R22BX

SECOND FINAL NOTICE

DATE: April 17, 2024
TO: Blue Bird Owners
Subject: R22BX: Roush Zinc Plated Return Line Fittings

SUBJECT: R22BX: Roush Zinc Plated Return Line Fittings

Installation of New Return Fuel Line at FRPCM (top of engine). **Read pages #12 and #14 before performing this procedure.**

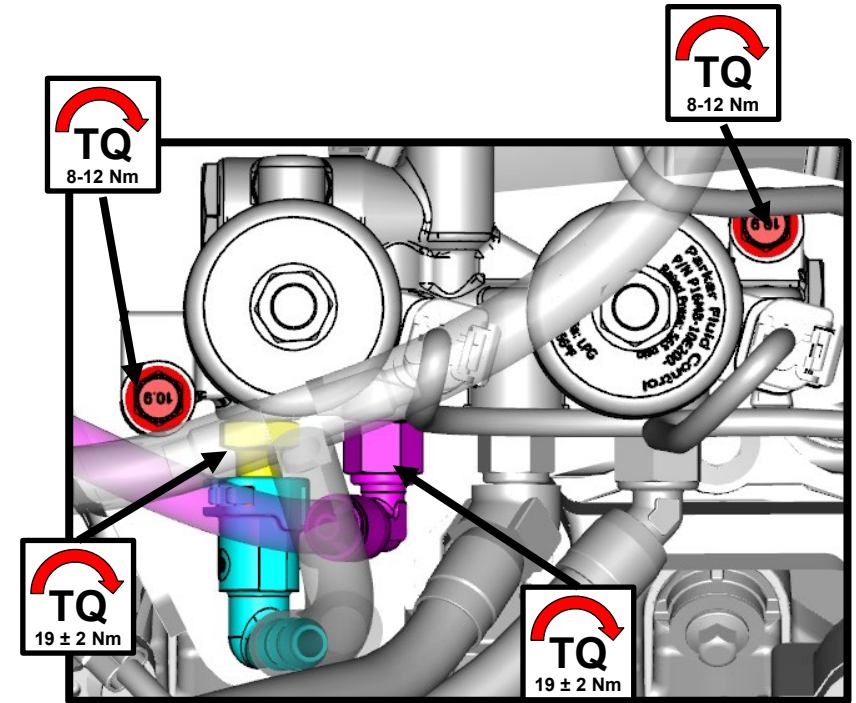
1. Ensure that the new return fuel line is routed properly on top of engine. See **Page #16** to verify routing.
2. Attach new Return Fuel Line at the FRPCM (**purple**). Slowly **hand tighten** to not damage the FRPCM.
3. Torque the new Return Fuel Line to the FRPCM to 19Nm ± 2Nm using an 11/16" crows' foot and torque wrench.
4. Re-install the Bleed port (**yellow**) and torque to 19 ± 2Nm using a 5/8" crows' foot and torque wrench, or a 5/8" deep-well socket and torque wrench.
5. Then push the EVAP hose (**light blue**) back onto the Bleed Port and listen for an audible "click" sound. Give the connector a light pull to verify that it has properly engaged with the Bleed Port Fitting.
6. Torque the FRPCM mounting bolts (**red**) to 8-12 Nm.

Description	Torque
Fuel Vapor Outlet (Bleed Port- Yellow)	19 ± 2Nm
Fuel Rail Return Outlet (Purple)	19 ± 2Nm
FRPCM Mounting Bolts (Red)	8-12 Nm

Installation of New Return Fuel Line at FRPCM (top of engine). **Read pages #13 and #14 before performing this procedure.**

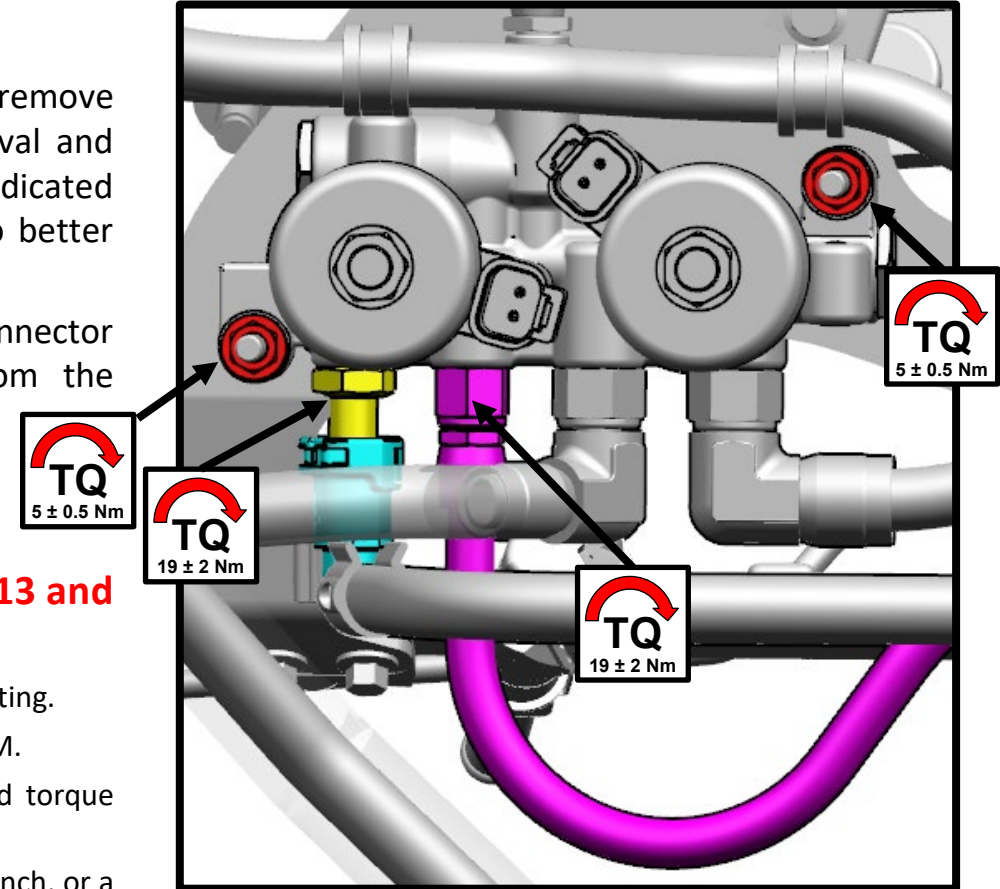
1. Ensure that the new return fuel line is routed properly on top of engine. See **Page #18** to verify routing.
2. Attach new Return Fuel Line at the FRPCM (**purple**). Slowly **hand tighten** to not damage the FRPCM.
3. Torque the new Return Fuel Line to the FRPCM to $19 \pm 2\text{Nm}$ using an 11/16" crows' foot and torque wrench.
4. Re-install the Bleed port (**yellow**) and torque to $19 \pm 2\text{Nm}$ using a 5/8" crows' foot and torque wrench, or a 5/8" deep-well socket and torque wrench.
5. Then push the EVAP hose (**light blue**) back onto the Bleed Port and listen for an audible "click" sound. Give the connector a light pull to verify that it has properly engaged with the Bleed Port Fitting.
6. Torque the FRPCM mounting bolts (**red**) to $5 \pm 0.5\text{ Nm}$.

Description	Torque
Fuel Vapor Outlet (Bleed Port- Yellow)	$19 \pm 2\text{Nm}$
Fuel Rail Return Outlet (Purple)	$19 \pm 2\text{Nm}$
FRPCM Mounting Bolts (Red)	$5 \pm 0.5\text{ Nm}$

Preparing New Return Fuel Line for Installation

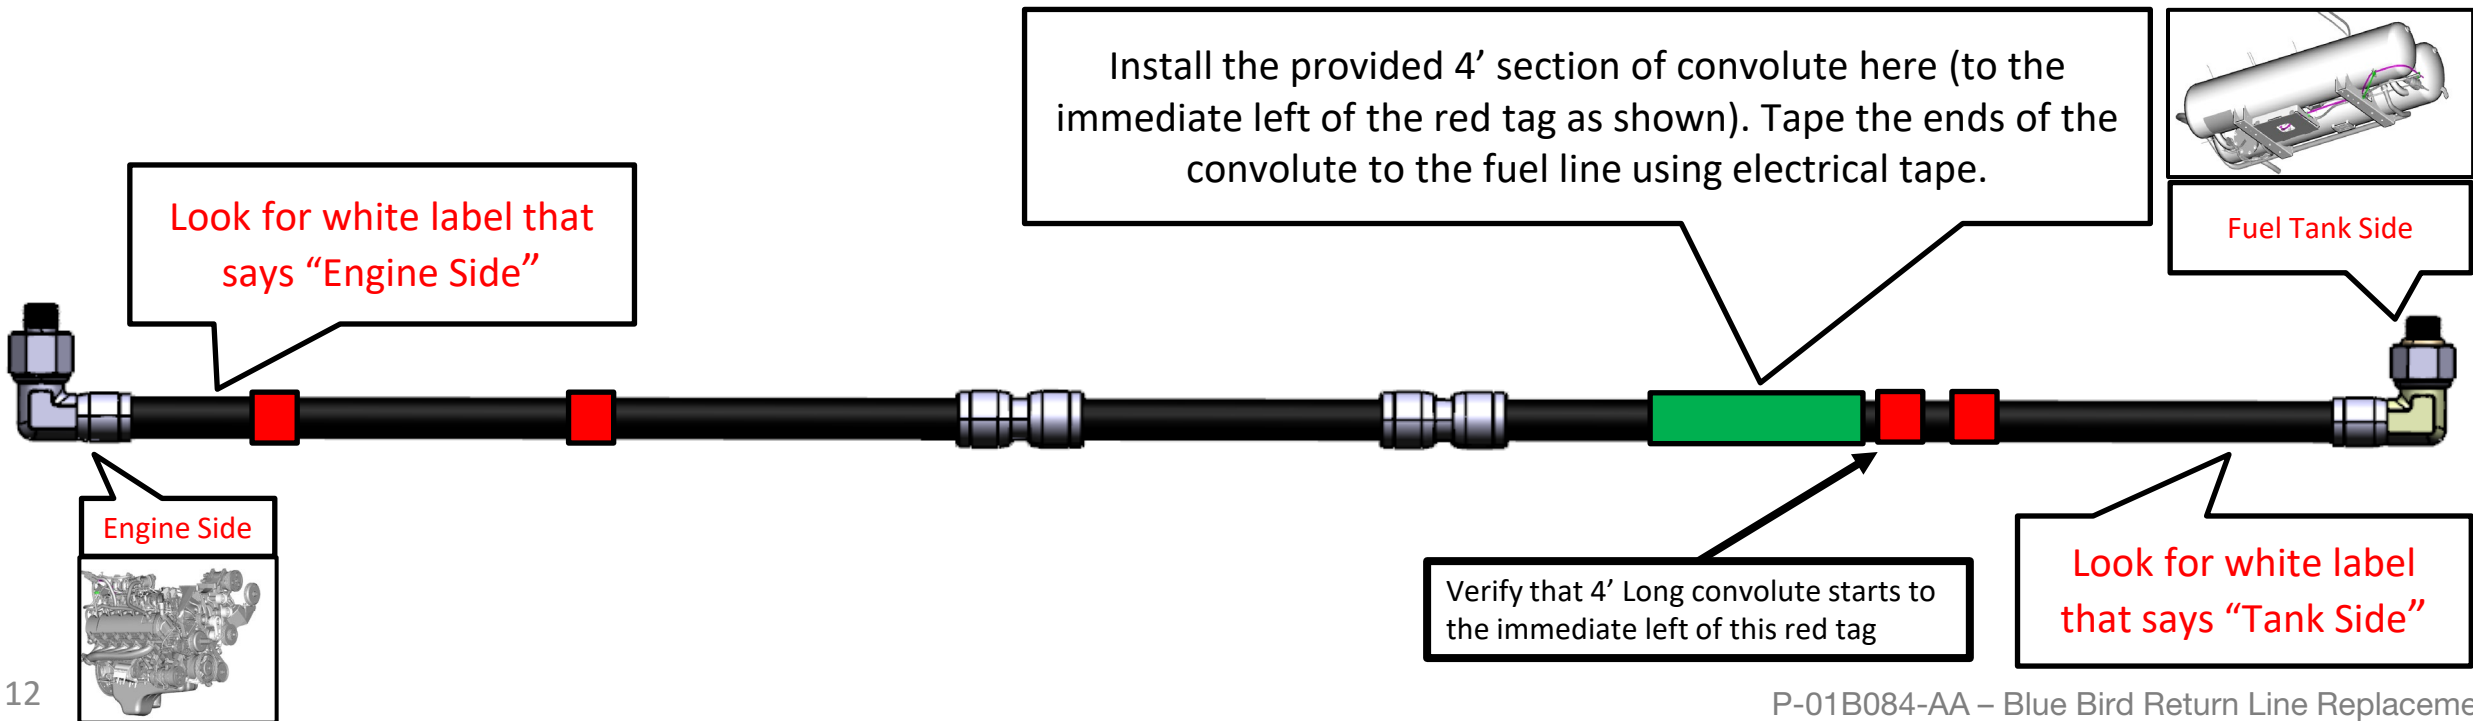
1. Verify that the new Return Fuel Line appears as shown in the image below (**Gen 4 only**).
2. **Do not** remove the plastic coverings from the end fittings until the time comes to install these fittings into their designated locations on the vehicle (as described in this manual). These coverings protect the fuel line from internal contamination during the installation process.
3. Pre-install provided 4' Long Convolute (P/N PLS-34-100-B-1219) to the fuel line at the indicated location. Retain the ends of it in place with electrical tape. The tape will ensure that the convolute stays in position during fuel line installation.

Preparing New Return Fuel Line for Installation

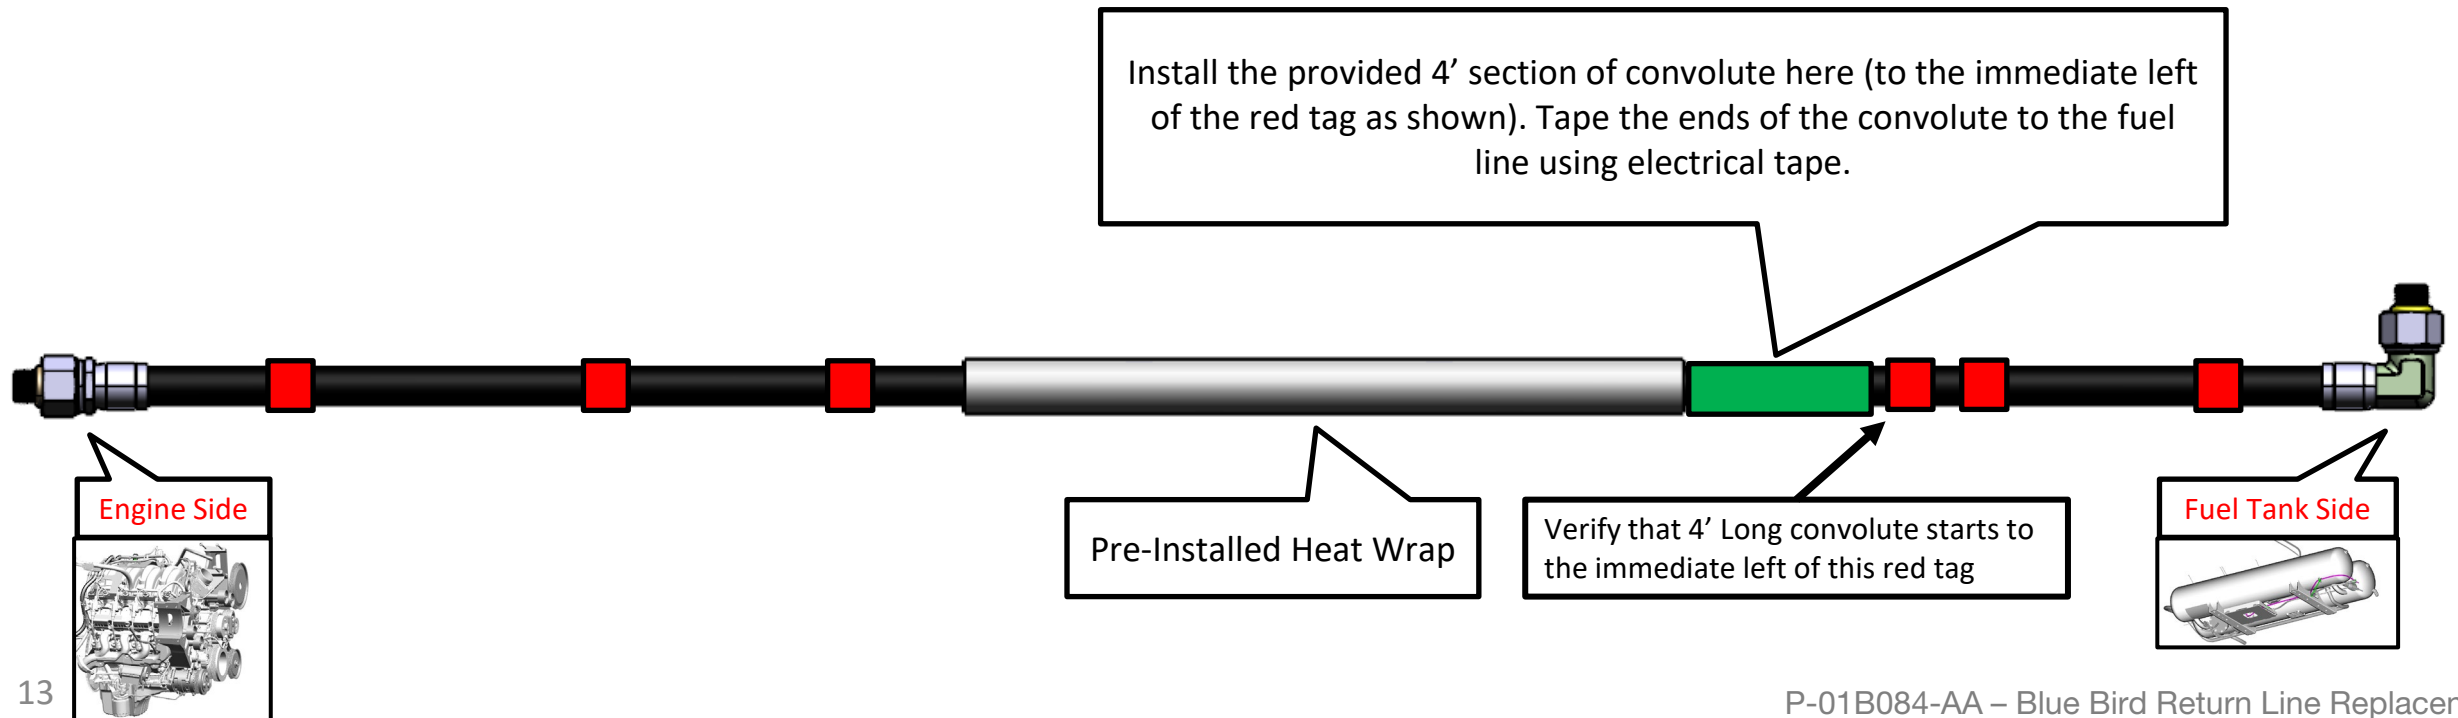
1. Verify that the new Return Fuel Line appears as shown in the image below (**Gen 5 only**).
2. **Do not** remove the plastic coverings from the end fittings until the time comes to install these fittings into their designated locations on the vehicle (as described in this manual). These coverings protect the fuel line from internal contamination during the installation process.
3. Pre-install provided 4' Long Convolute (P/N PLS-34-100-B-1219) to the fuel line at the indicated location. Retain the ends of it in place with electrical tape. The tape will ensure that the convolute stays in position during fuel line installation.

Installation of the Return Fuel Line at the Engine

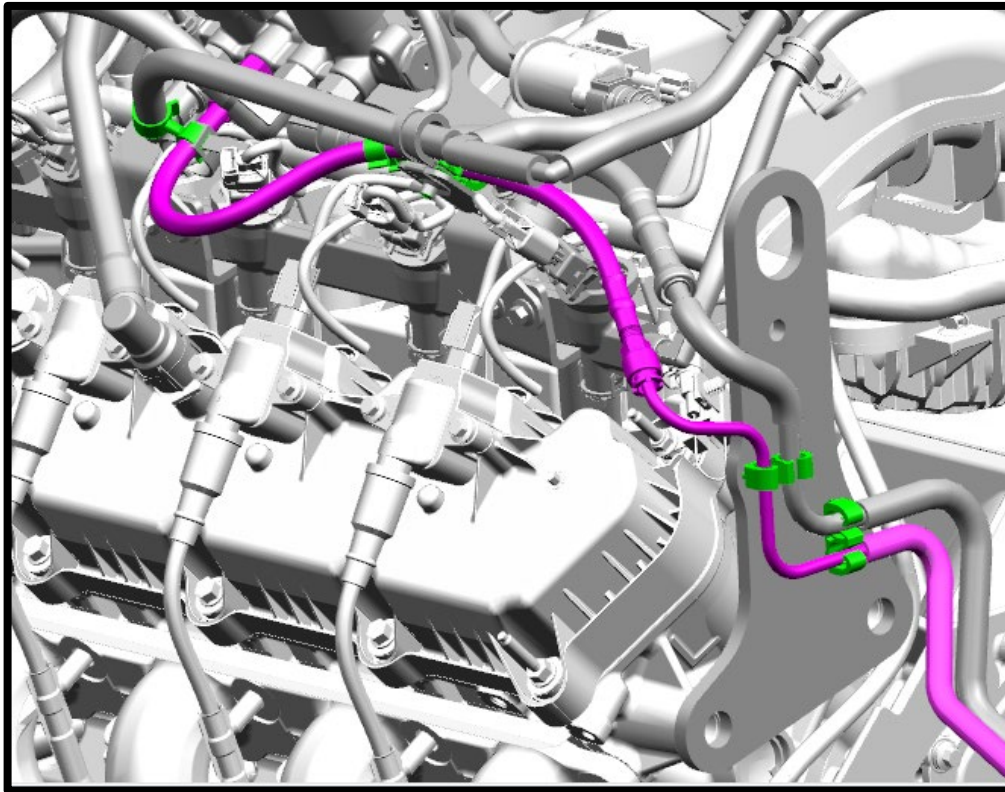
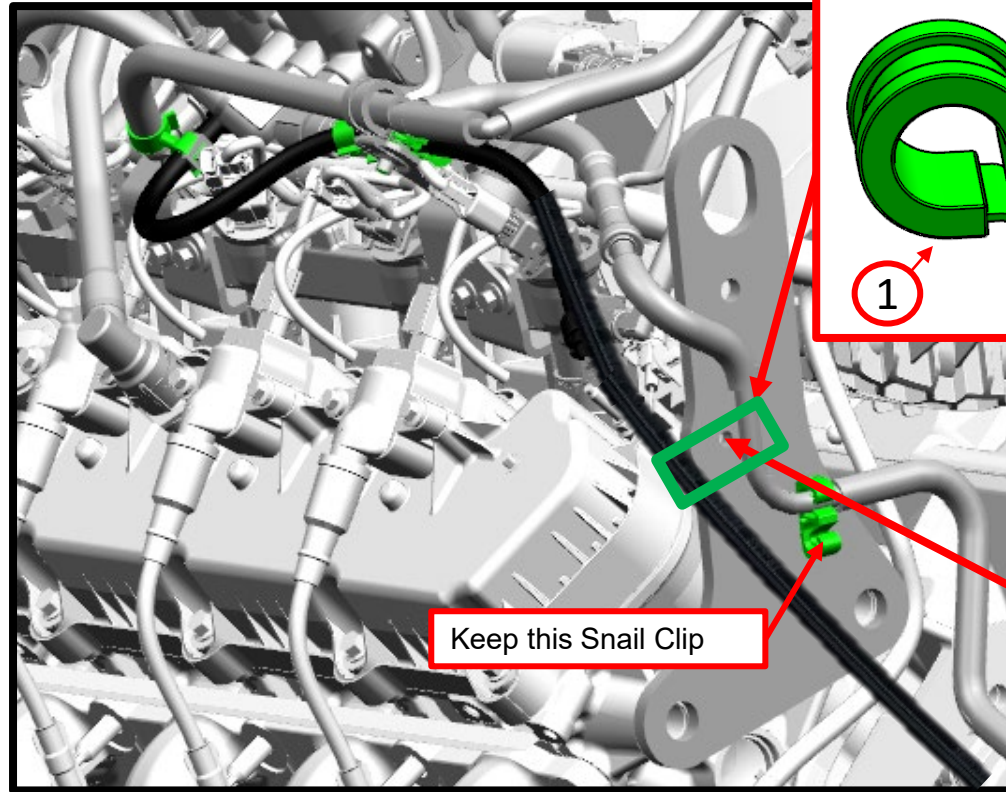
BEFORE NEW RETURN FUEL LINE

AFTER NEW RETURN FUEL LINE

Remove the original snail clip that was positioned here. Mount Plamps to the engine lifting bracket using the indicated hole.

Just behind the engine, remove the existing snail clip and use two Plamps to retain the existing Supply Fuel Line and the new Return Fuel Line. **A red tag on the return fuel line will indicate the proper location to clamp the new fuel line in place.**

Route the new Return Fuel Line and the existing Supply Fuel Line through the two supplied Plamps.

TQ
10 ± 2 Nm

Issue Description

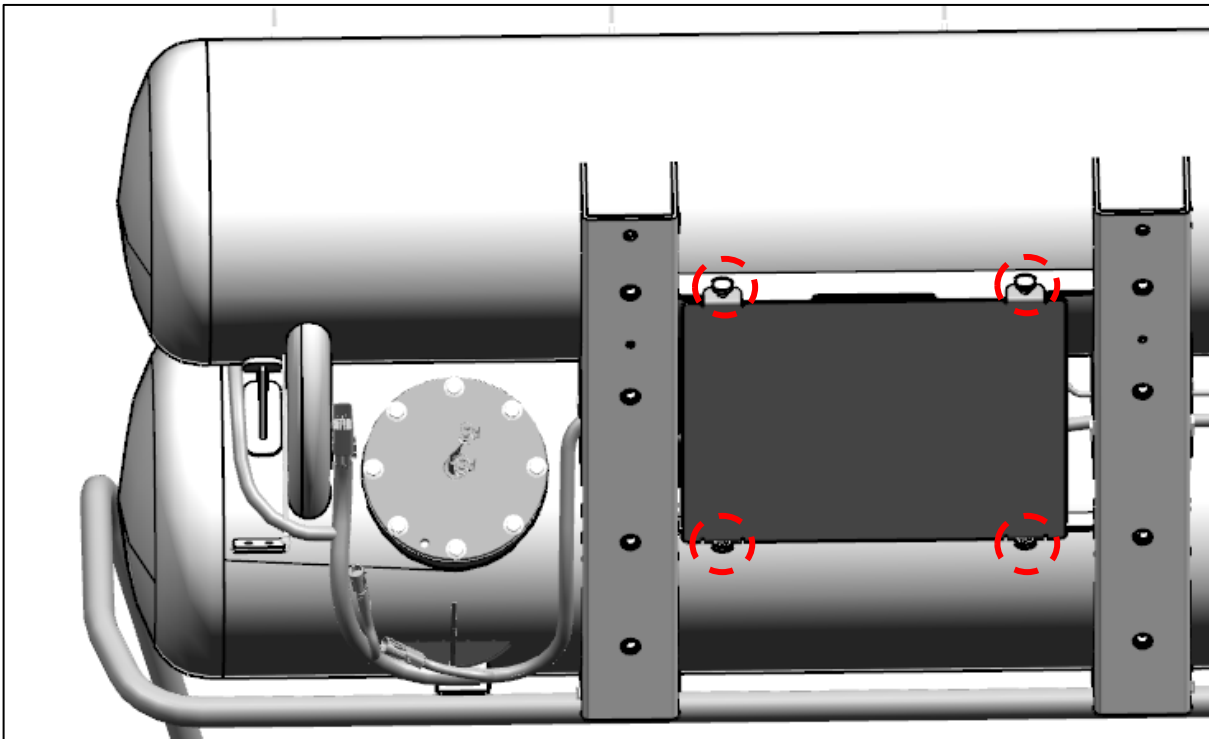
When removing the four thumb screws that retain the valve guard on Gen 4 Bluebird busses, it is possible for the thumb screws (circled in the picture below) to shear if they are corroded and seized onto the fuel tank. This procedure provides a corrective action if this happens.
